The Columbia Municipal Planning Commission will hold a Study session on Wednesday, January 11, 2023 and a Voting session on Wednesday, January 18, 2023 at 4:00 PM in Council Chambers in the basement of City Hall, 700 N. Garden Street.

Comment Response Letter – Final Plat – Summit at Carter's Station, Phase 1

DEVELOPMENT REVIEW COMMITTEE COMMENT FORM

Request from Allison Baldwin for final plat approval with surety of Summit at Carter's Station Phase 1 consisting of 58 lots off Freehand Road.

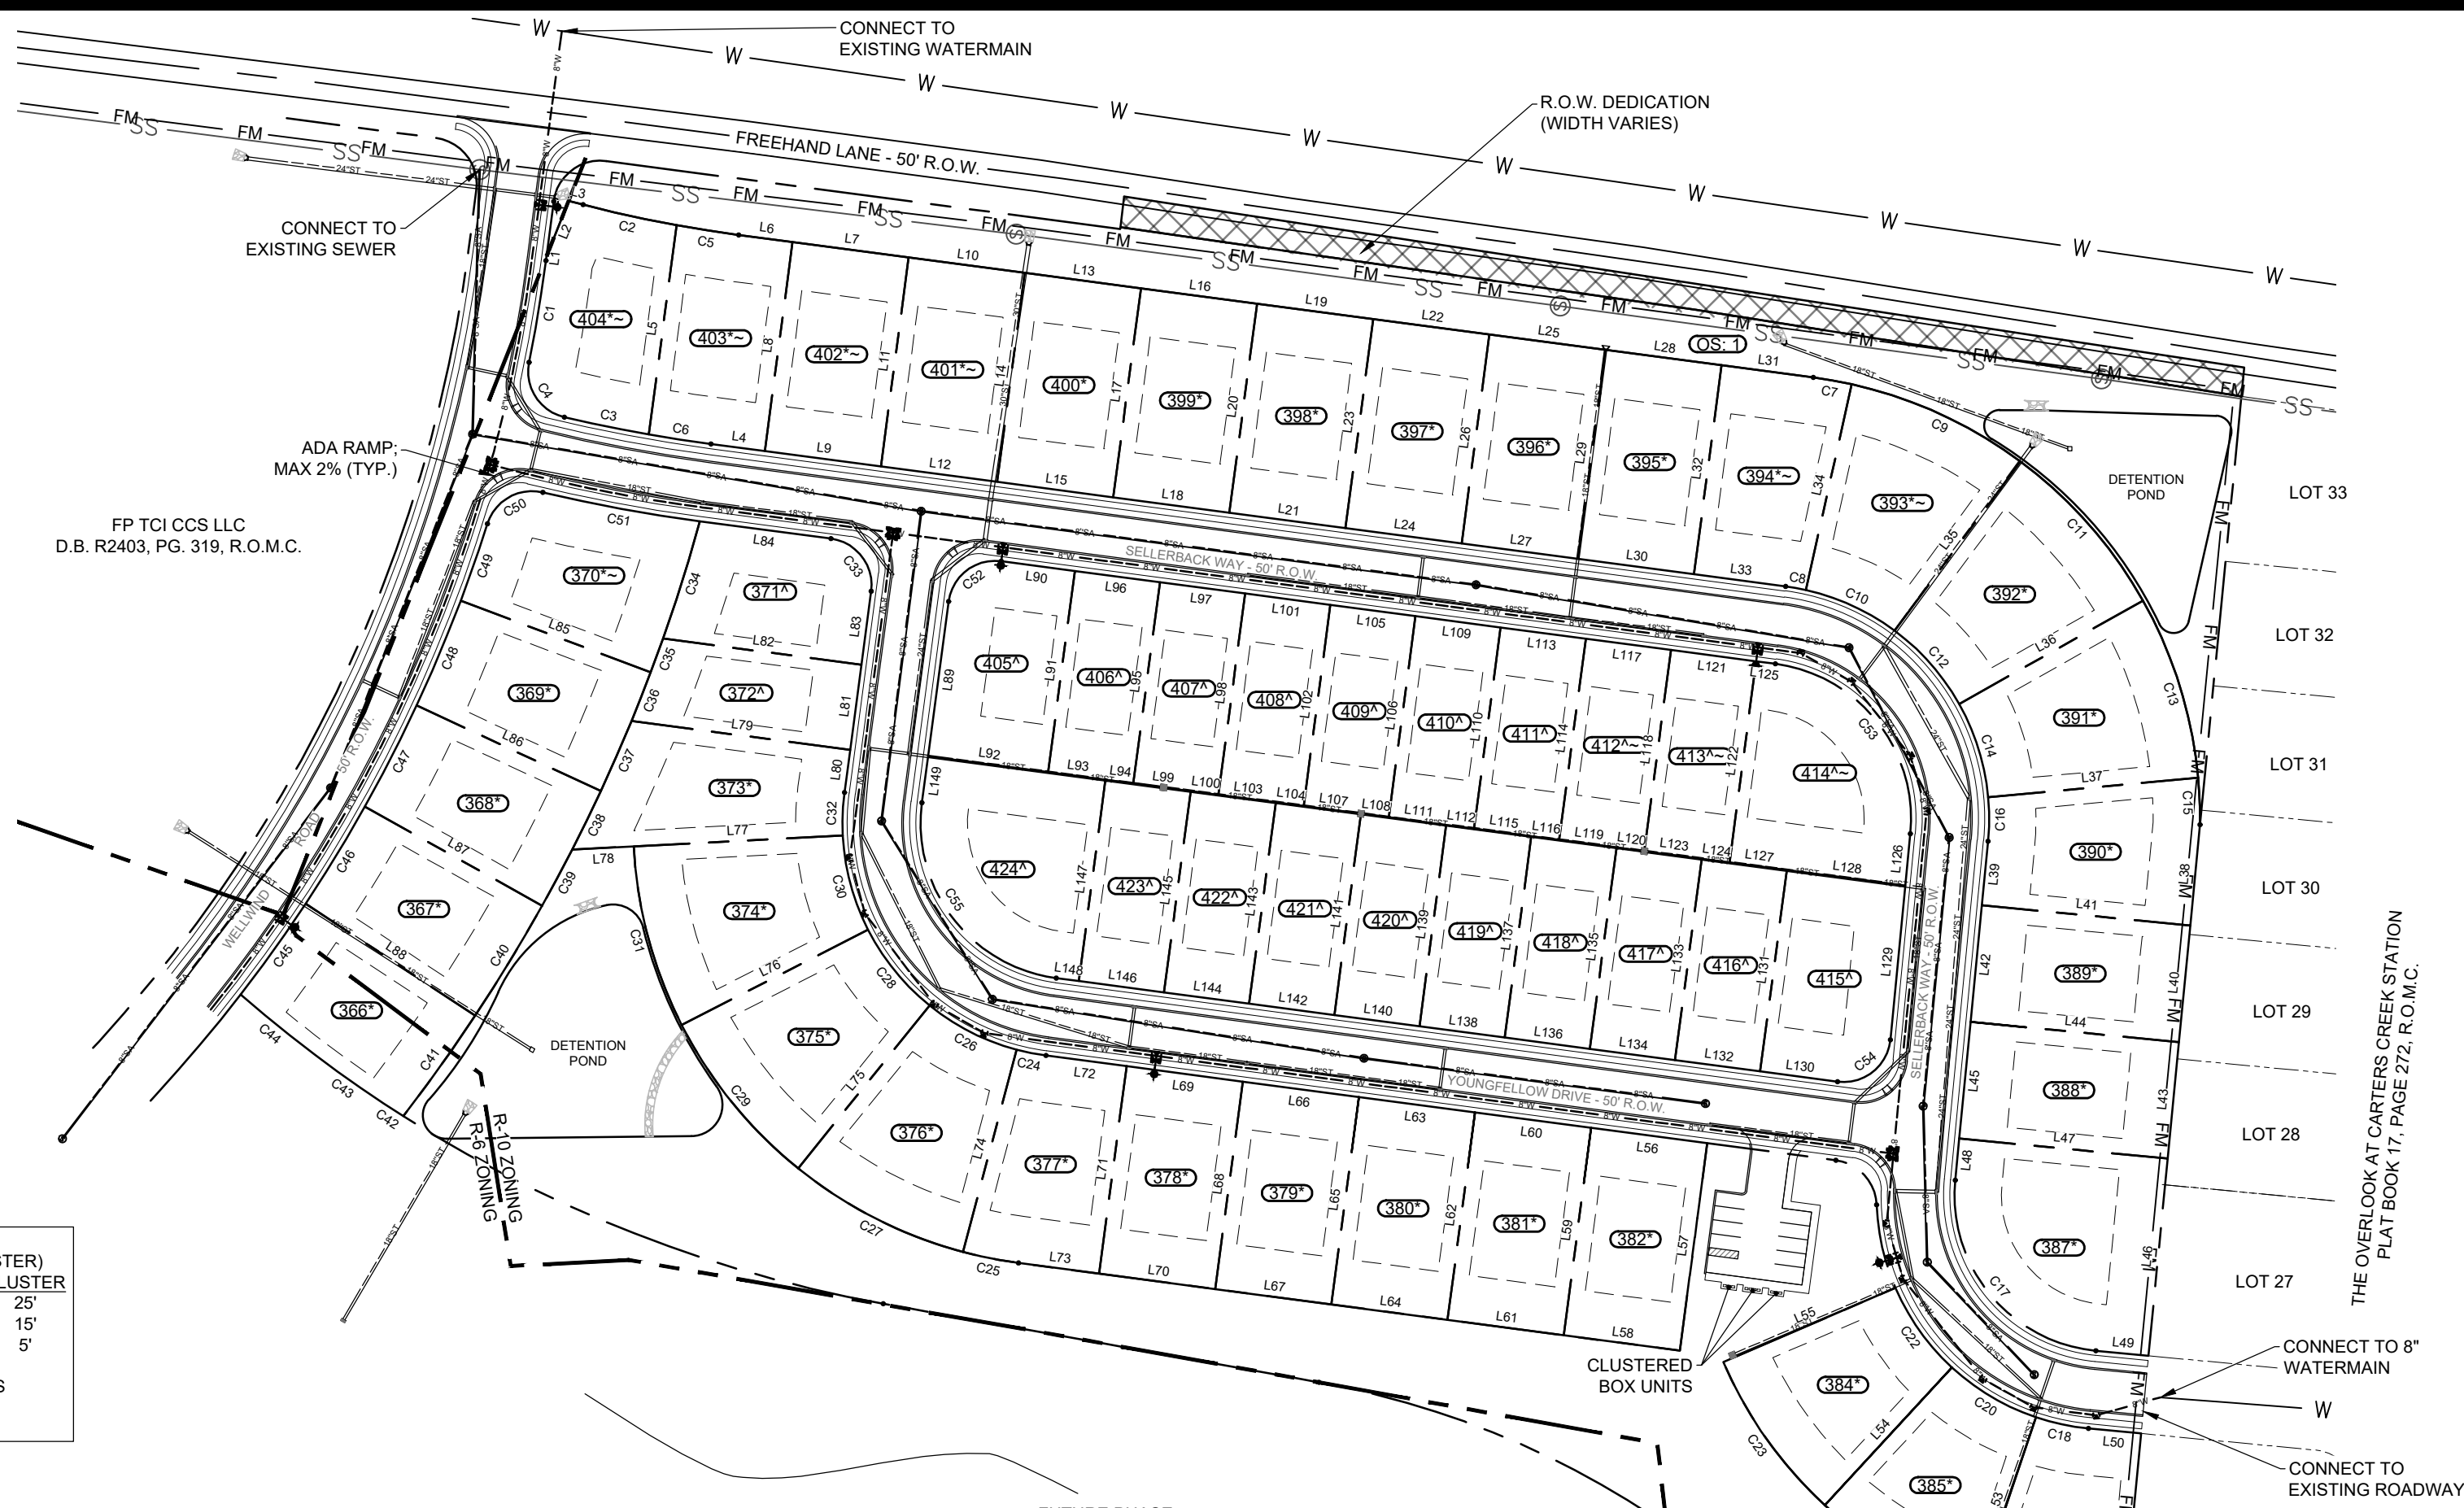
10. Site data and typical cluster layout not matching.
Comments addressed.
11. Please correct typical lot layout to reflect 10' side yard setback for non-cluster lots.
Comments addressed.

L2.0
LANDSCAPE BUFFER
PLAN

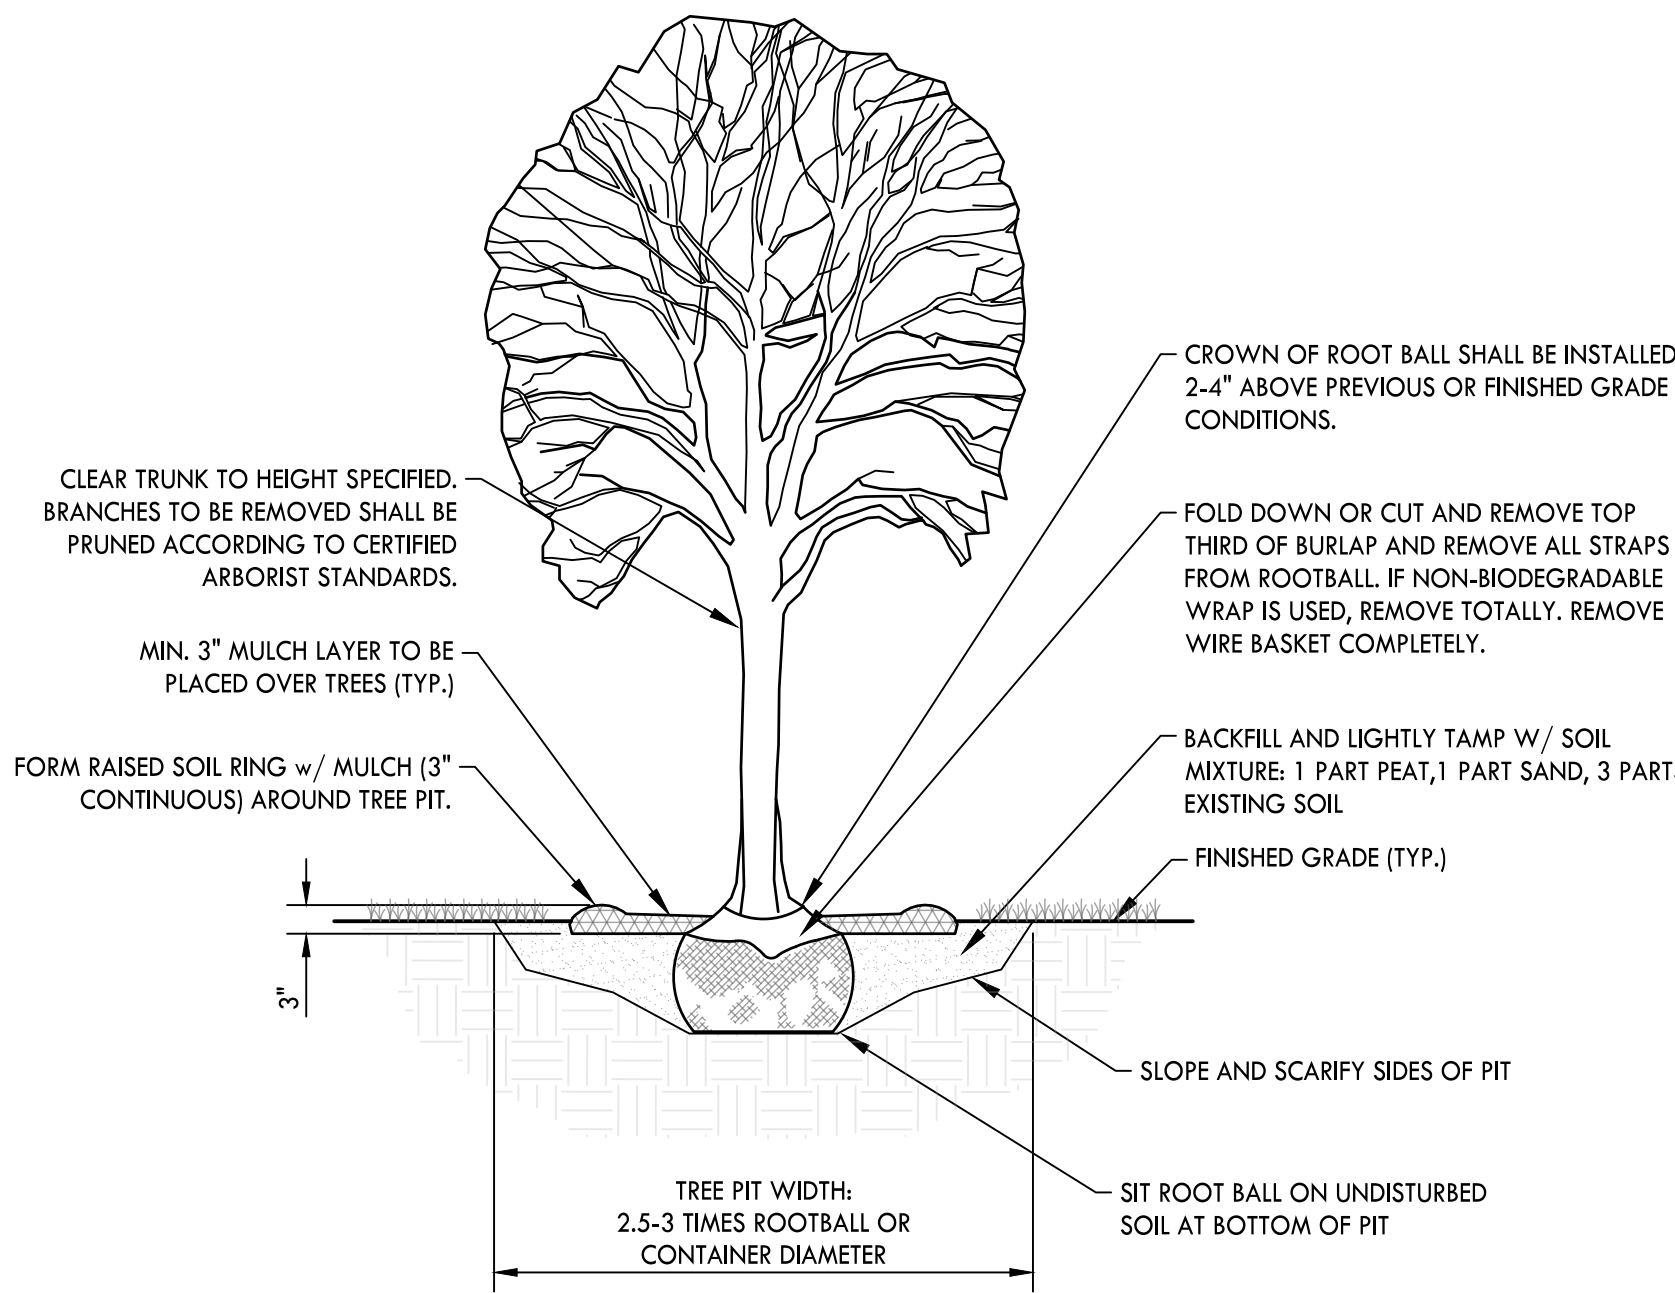
Response: Fence detail added to plan ON SHEET L2.0 6A & 6B
